Access Compliance Report

Public Rights-of-Way

(Curb Ramps)

Intersection ID: 53517	Main Street: STONEWELLS_DR	Cross Street: KINGAUSSIE_AV	Location: S
ADA ID: 2442D3B85BA3	Ramp Type: PerpDiag	Initial Pass/Fail: Fail	Overall Compliance: No
Severity Score: 8.75			
Codes/Mitigation Info/Possible Solution		Field Measurements/Component Compliance

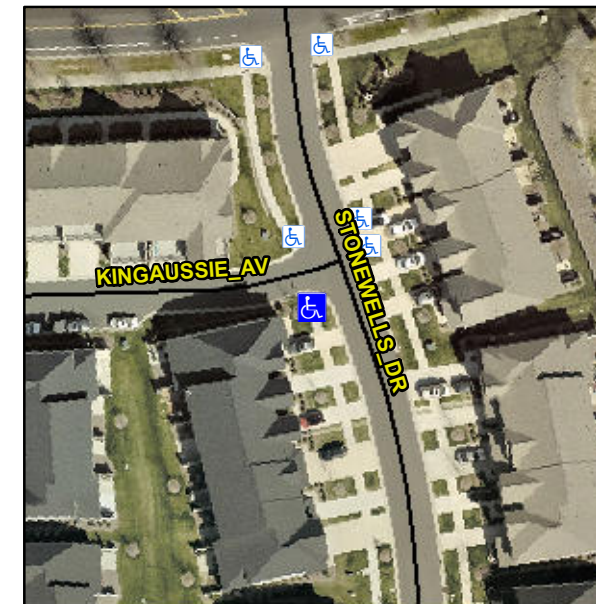
R304.5.1

Compliance	Description	Data	Compliance	Description	Data
N/A	Ramp Length (in)	66.0	Yes	Ramp Slope (%)	7.7
No	Ramp Width (in)	45.0	Yes	Ramp XSlope (%)	0.6
N/A	Flare Type LT	N/A	N/A	Flare Type RT	N/A
N/A	Flare Slope LT (%)	N/A	N/A	Flare Slope RT (%)	N/A
N/A	Flare Traversable LT?	N/A	N/A	Flare Traversable RT?	N/A
N/A	Landing Length (in)	N/A	N/A	DWS Provided?	N/A
N/A	Landing Width (in)	N/A	N/A	DWS Contrast?	N/A
N/A	Landing Slope (%)	N/A	N/A	DWS Length (in)	N/A
N/A	Landing X Slope (%)	N/A	N/A	DWS Full Width?	N/A
N/A	Landing Curb? (Y/N)	N/A	N/A	DWS Offset (in)	N/A
N/A	Shared Landing?	N/A			
N/A	Gutter Ponding?	N/A	N/A	Gutter Slope (%)	N/A
N/A	Gutter Lip Ht (in)	N/A	N/A	Gutter X Slope (%)	N/A
N/A	Painted X Walk1?	No	N/A	Painted X Walk2?	No
	X Walk 1 Direction	To W		X Walk 2 Direction	To N
N/A	X Walk 1 Width (in)	N/A	N/A	X Walk 2 Width (in)	N/A
	X Walk 1 Slope (%)	0.6		X Walk 2 Slope (%)	1.1
	X Walk 1 X Slope (%)	1.3		X Walk 2 X Slope (%)	0.3

Remove & Replace Curb Ramp With Two New Directional Ramps or Equivalent.
